TIS Service Bulletin Page 1 of 2

# FALSE WARNINGS THAT THE FRONT PASSENGER SEAT IS OCCUPIED WITHOUT THE SEAT BELT BUCKLED

This Service Information bulletin supersedes SI B72 04 17 dated February 2018

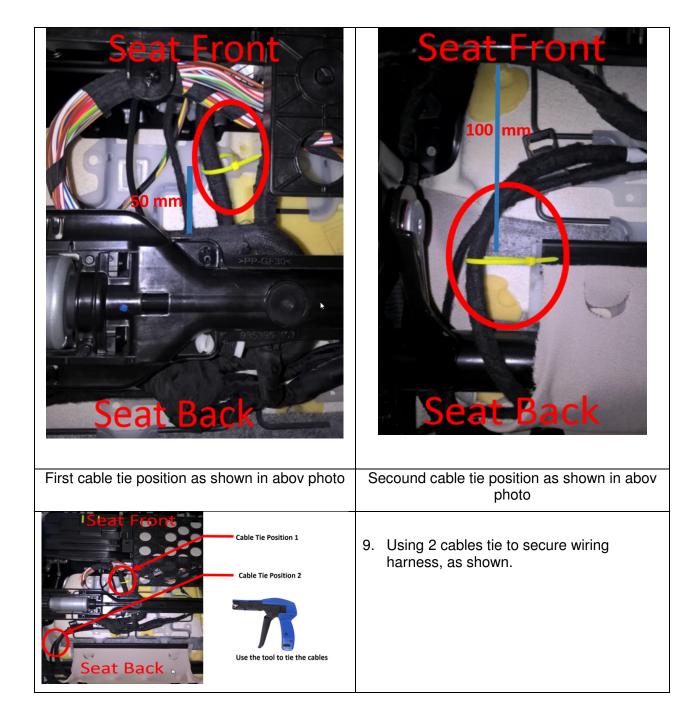
- 4. Check the plug for conditions resulting in possible poor electrical connection corrosion, bent pins, etc. removing control unit if needed, as shown.
- 5. Repair any connection problems.
- 6. Securely re-install control unit, if removed.
- 7. Reconnect plug into CIS.

8. Secure the loose clip attached to cables, as shown.
